We would like to thank the two Referees for the constructive comments on our manuscript. Please find our point-by-point reply below.

Anonymous Referee #2 (Major revisions)

Anonymous Referee #3 (Minor revisions)

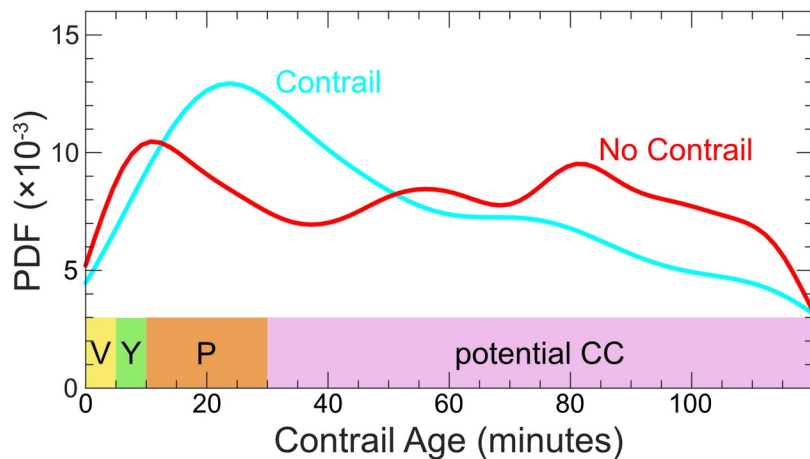
Contrail formation requires fulfillment of the Schmidt-Appleman criterion, according to Schumann (1996), independent of the environmental conditions or preexisting cloudiness. Persistent contrail existence requires ice-supersaturation of the embedding air mass. Following e.g. Kärcher (2018), climate-impactful contrail-cirrus develop from persistent contrails only, when they spread out into contrail-cirrus by wind shear perpendicular to the line shape of the persistent contrail, so that they cover a large area. That means, persistent contrails can exist for a long period but may have no climate impact as long as they keep their line shape. In contradiction to this concept, Figure 11 suggests that all persistent contrails develop into contrail-cirrus.

The reviewer is correct that we have been imprecise with some formulations. We have worked through the manuscript to improve the text as shown below. We have also revised Fig. 11 and its caption to clarify that large contrail age constitutes “*potential contrail cirrus can form when persistent contrails are spread out spatially as a result of wind shear.*”

Figure 2. 2d histogram of particle backscatter coefficient (β) and particle linear depolarization ratio (δ) for the WALES cirrus observations during ML-CIRRUS.

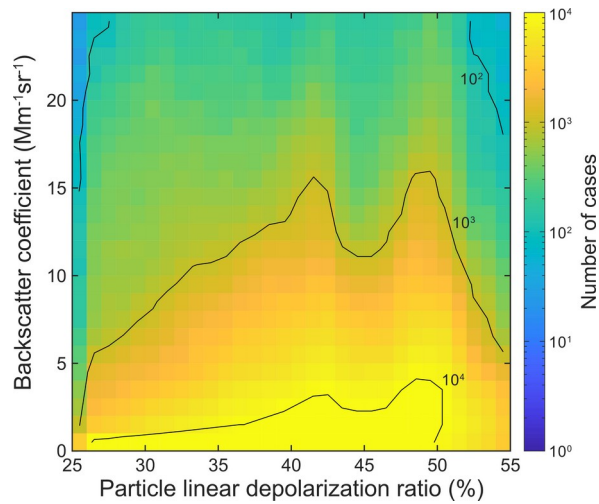
3| The presentation of important results of this study in Figures 2 and 8 suffer from a “diffuse” presentation. In Figure 2, the “clean” and “polluted” cases are hardly identifiable given the chosen color scheme. Adding contour lines or selecting another color scheme may improve these figures and may make the contained information more visible. In Figure 8, extracting the relevant information is even more difficult. In Figure 8a, there is no difference identifiable between perturbed and unperturbed cases. The inserted lines simply represent the threshold values but the consequences for the distribution of the observed cases are difficult to identify. It is recommended to re-work the presentation of the figures.

We have revised Figures 2, 8, and B2 as suggested by changing the color table and adding contour lines. The figures now look as shown below.

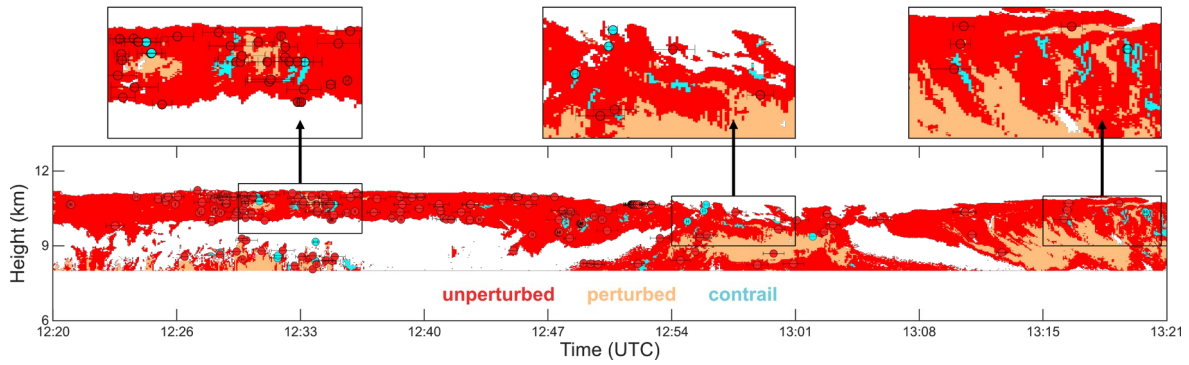
Line 92: In Sect. 2.4, where the advection correction and intercept matching based on ERA5 winds are introduced, and in Sect. 3.2–3.3, where spatial offsets between masked regions and confirmed intercepts are discussed, the uncertainty associated with the advection correction deserves more quantitative treatment. Since the validation relies on predicted intercept locations, errors in wind fields, headings, and timing may contribute to both false negatives and apparent false positives. The authors might consider estimating and reporting an uncertainty range for the advected intercept positions and discussing how this uncertainty affects the interpretation of the detection performance.

Thank you for this comment. We agree that the current presentation of the intercept points in Figures 9 and 10 gives the impression that those are infallible findings. The location of the intercept point is strongly affected by the ERA5 wind field used for matching. For the error analysis added to Figure 9, we assume that wind direction is accurately represented but wind speed could be off by 1 m s^{-1} .

We have furthermore added the following text to Sect. 3.2 at the end of the discussion of Figure 9:

“Finally, the error bars on the location of the intercept points indicate scaling with the time delay between the two aircraft, i.e., the temporal difference dominates over the wind-speed error. Lowering the accepted time delay of currently 2 h would be a straightforward measure for reducing the error in the location of the projected intercept points.”

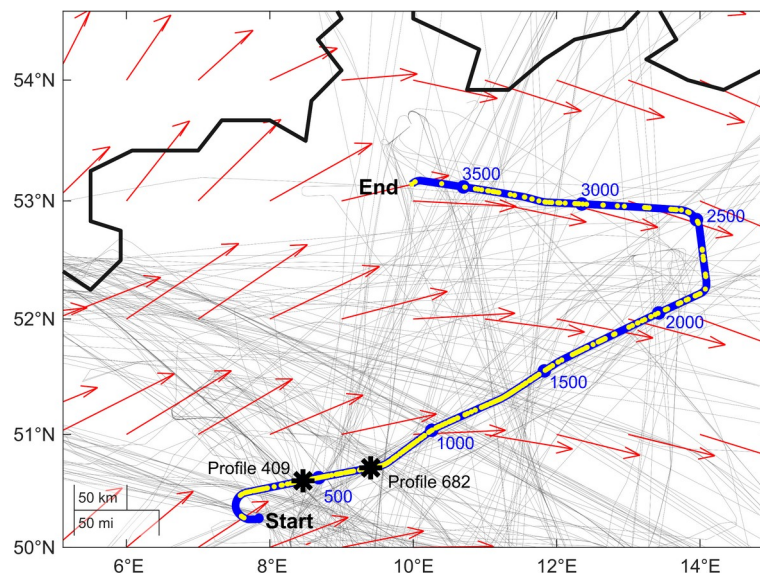
Figure 5: The authors may consider adding the tracks of the relevant commercial aircraft (if feasible) and possibly the ERA5 background winds to better place the observations in context. In addition, it would be helpful to more clearly indicate the locations of the selected profiles discussed later in Fig. 6 and in the main text, as these are currently difficult to see.

Excellent suggestions. We have revised Figure 5 accordingly. It now looks like this:
